THE CLEVELAND ELECTRIC ILLUMINATING COMPANY

August 9, 1985
PY-CEI/NRR-0313 L

Perry Nuclear Power Plant
Docket Nos. 50-440; 50-441
Fracture Toughness
RCPB Materials
SER Confirmatory Issue 17

Attached are proposed revisions to the FSAR associated with fracture toughness of the Reactor Coolant Pressure Boundary (RCPB) materials as requested by your staff. These will be incorporated in a future FSAR amendment. A Technical Specification bases page associated with this revision is also attached.

Figure 5.3-2

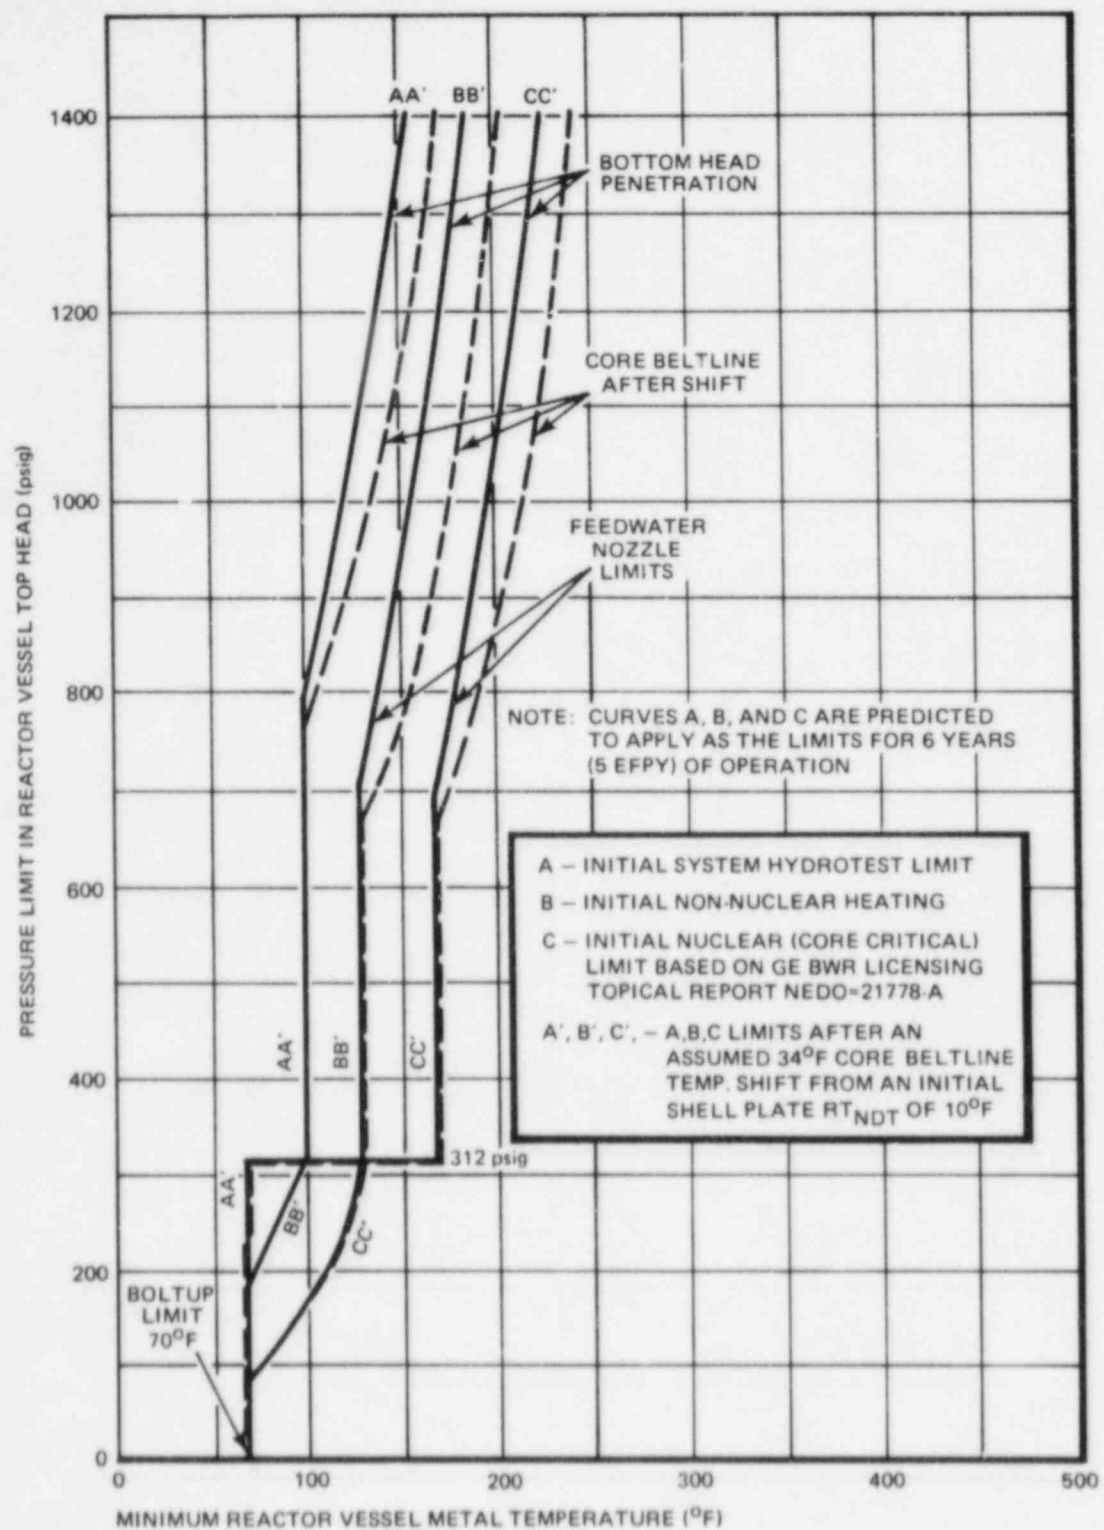
The fracture toughness analysis for system pressure tests resulted in the curves labeled A shown in Figures 5.3-2 (Perry 1) and 5.3-3 (Perry 2). The curves labeled "core beltline" are based on an initial RT_{NDT} of 10°F for the plate material for Perry 1, and an initial RT_{NDT} of -20°F for the plate material for Perry 2.

The fracture toughness analysis was done for the normal heatup or cooldown rate of 100°F/hour. The temperature gradients and thermal stress effects corresponding to this rate were included. The results of the analyses are a set of operating limits for non-nuclear heatup or cooldown shown as curves labeled B on Figures 5.3-2 and 3. Curves labeled C on Figures 5.3-2 and 5.3-3 apply whenever the core is critical.
